W. Harrison Welch, PE
Stonewall Structural Engineering, PLLC
9203 Baileywick Rd. #200
Raleigh, NC 27615
(919)407-8663

Brandon Dyer
Tar Heel Basement Systems
3333 Air Park Rd.
Fuquay-Varina, NC 27526

Re: Review of Proposed Foundation Repairs — 380 Senter Lane, Bunnlevel, NC 28323

Detail 1 – Interior Pier Stabilization

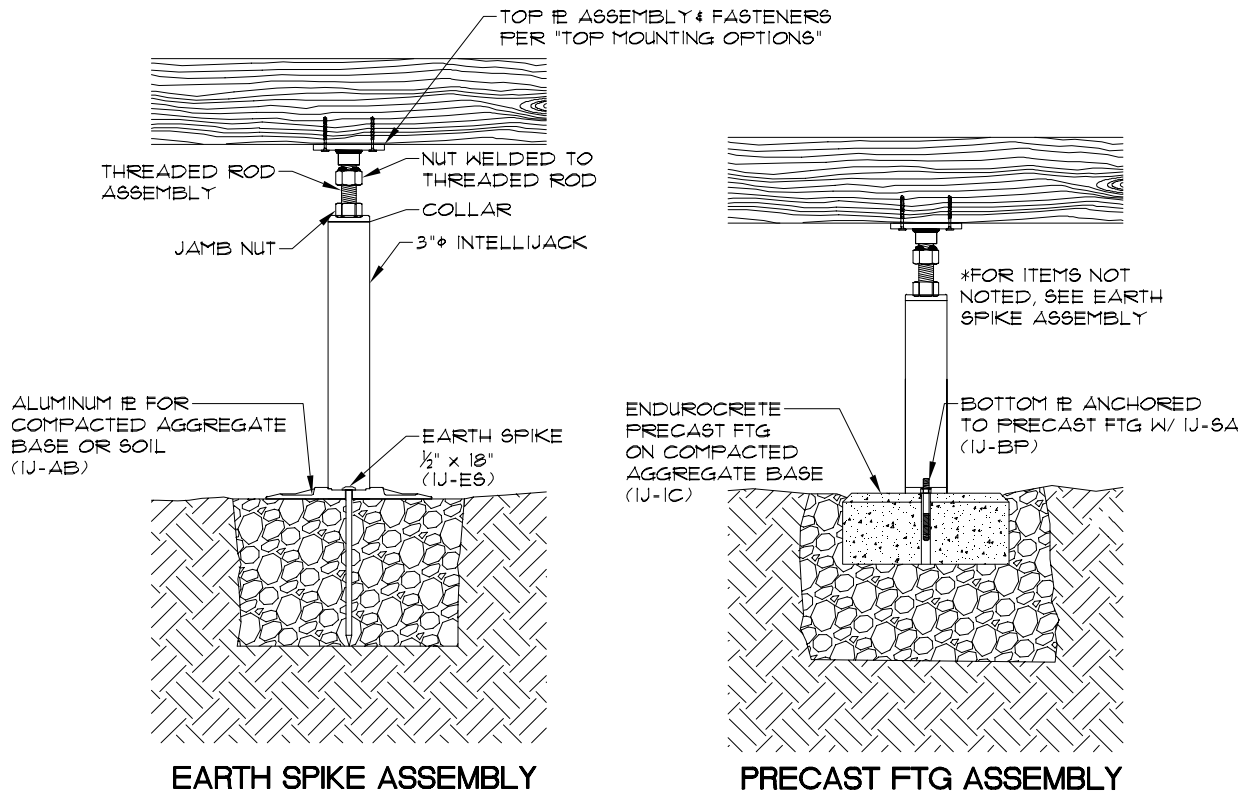
1. Reinforce each girder span adjacent to the cracked CMU pier using an IntelliJack support on a well-compacted 18"x18"x18" gravel footing. Two (2) IntellisJacks required. Jacks should be located within 18" of the cracked pier (*see Drawings 1-2 for details*).

- Each new gravel footing should be located such that the edge of the new footing abuts the existing footing for the cracked pier.
 - If the existing footing projection is found to be larger than 8", then the IntelliJack should be anchored directly to the existing footing and the gravel footing omitted.

2. Install tight-fit treated or steel shim material at the out-of-contact pier such that the pier is in contact with the girder.
 - To lessen the likelihood of future differential settlement of the pier, one additional IntelliJack support may be installed at the mid-span of the girder to the left of the out-of-contact pier. The new support should be centered on a well-compacted 18"x18"x18" gravel footing (*see Drawings 1-2 for details*).
